These drawings are for a non-material amendment application to the previously approved design, reference '221645'. Changes annotated on the drawings & are as follows:
1. Gable window enlarged;
2. Additional rooflights

South Hill, Upper Warren
Avenue, Caversham. RG4 7EB

Roof Plan, Elevations & 3D
Views - Proposed GA

Sheet Ref.	MAP-C4405-280	Rev.	D
Project Ref.	C4405	Date	14.07.2026
Drawn by	FM	Checked by	JMR
Scale	1 : 100	Sheet Size	A1

Proposed Roof Level Plan
General Arrangement | RF-RDG | Scale 1 : 100

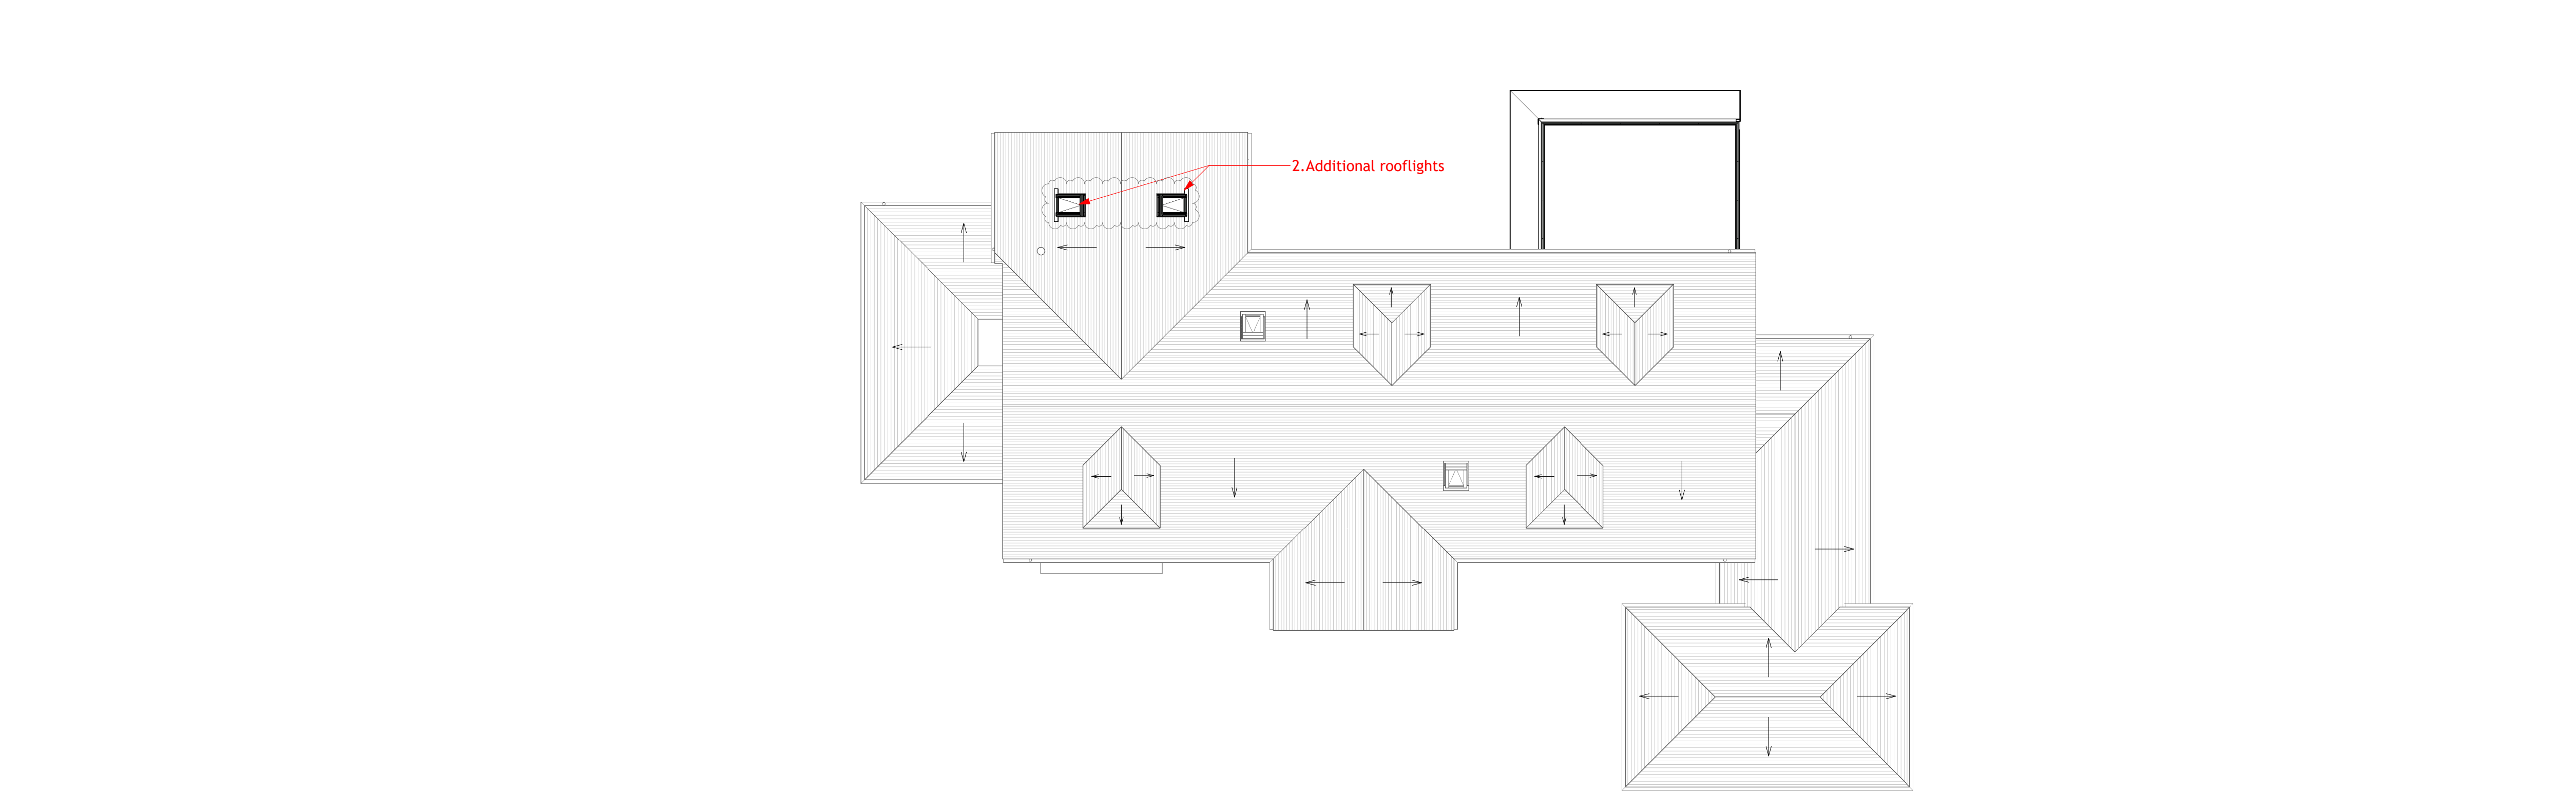
D	14.07.2026	FM	Gable window changed to 3No. panes
C	30.06.2026	FM	Gable window & rooflights
B	08.08.2023	FM	Juliet balcony & window W02/01 works not to be carried out
A	15.03.2023	FM	Second issue
0	14.10.2022	CB	Planning issue
